TECHNICAL MEMO

Project	362 Jones Road Drury
Subject	Section 92 Request for Information: BUN60440759
From:	Leo Hills
Date	24 November 2025

Figure 11-1: Locations of Crashes

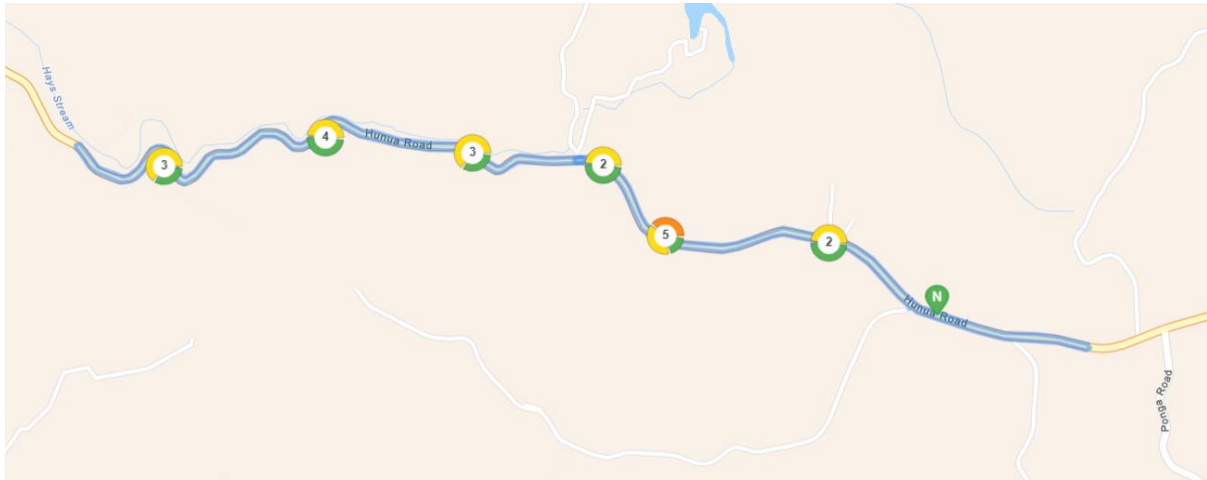
AT would like the applicant to provide more analysis of the locations of the loss-of-control crashes. We want to see if there are any particular curves or other locations where improvements to that part of the road could be used as mitigation the proposal, rather than asking the applicant to upgrade/widen the whole road.

- A more detailed assessment has been assessment of the surrounding area's road safety record has been undertaken using the NZTA's CAS database for only loss of control crashes in the gorge itself (from the Quarry entrance to the site entrance). Crash records for the five year period 2020 - 2024 including all available records for 2025. The results show:

- A total of 20 loss of control crashes were recorded in the above study area, comprising of 8 non-injury crashes, 10 minor-injury crashes, and 2 serious-injury crashes.

- It should be noted that 8 of these loss of control crashes (40%) occurred at night when the fill site will not be operating.
 - Figure 11-1 below shows the approximate location of the above crashes within the study area. In general, the loss of control crashes are quite spread out along the corridor.

- Areas A and C/D in Figure 3-1 previous had three loss of control crashes each, while Area B did not have any.
